# Access Compliance Report

## Public Rights-of-Way

Intersection ID: 47908	Main Street: UNIVERSITY_CITY_BV	Cross Street: UNIVERSITY_CITY_BV	Location: NW
ADA ID: 3B9681338C50	Ramp Type: Perp	Initial Pass/Fail: Fail	Overall Compliance: No
Severity Score: 21.25			
Codes/Mitigation Info/Possible Solution		Field Measurements/Component Compliance

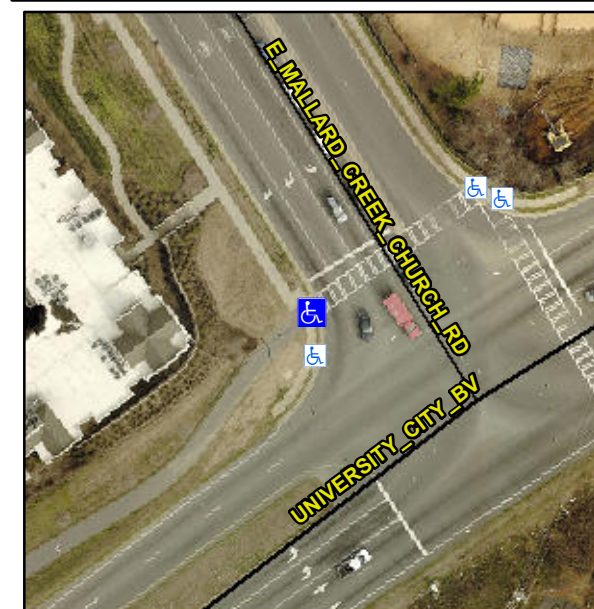
**Not Found, R304.5.1, R304.2.2**

Compliance	Description	Data	Compliance	Description	Data
N/A	Ramp Length (in)	70.5	No	Ramp Slope (%)	8.6
No	Ramp Width (in)	40.0	Yes	Ramp XSlope (%)	1.2
N/A	Flare Type LT	N/A	N/A	Flare Type RT	N/A
N/A	Flare Slope LT (%)	N/A	N/A	Flare Slope RT (%)	N/A
N/A	Flare Traversable LT?	N/A	N/A	Flare Traversable RT?	N/A
N/A	Landing Length (in)	N/A	N/A	DWS Provided?	N/A
N/A	Landing Width (in)	N/A	N/A	DWS Contrast?	N/A
N/A	Landing Slope (%)	N/A	N/A	DWS Length (in)	N/A
N/A	Landing X Slope (%)	N/A	N/A	DWS Full Width?	N/A
N/A	Landing Curb? (Y/N)	N/A	N/A	DWS Offset (in)	N/A
N/A	Shared Landing?	N/A			
N/A	Gutter Ponding?	N/A	N/A	Gutter Slope (%)	N/A
N/A	Gutter Lip Ht (in)	N/A	N/A	Gutter X Slope (%)	N/A
N/A	Painted X Walk1?	Yes	N/A	Painted X Walk2?	N/A
	X Walk 1 Direction	To NE		X Walk 2 Direction	N/A
N/A	X Walk 1 Width (in)	113.0	N/A	X Walk 2 Width (in)	N/A
	X Walk 1 Slope (%)	1.5		X Walk 2 Slope (%)	N/A
	X Walk 1 X Slope (%)	0.0		X Walk 2 X Slope (%)	N/A

**Remove & Replace Entire Ramp.**
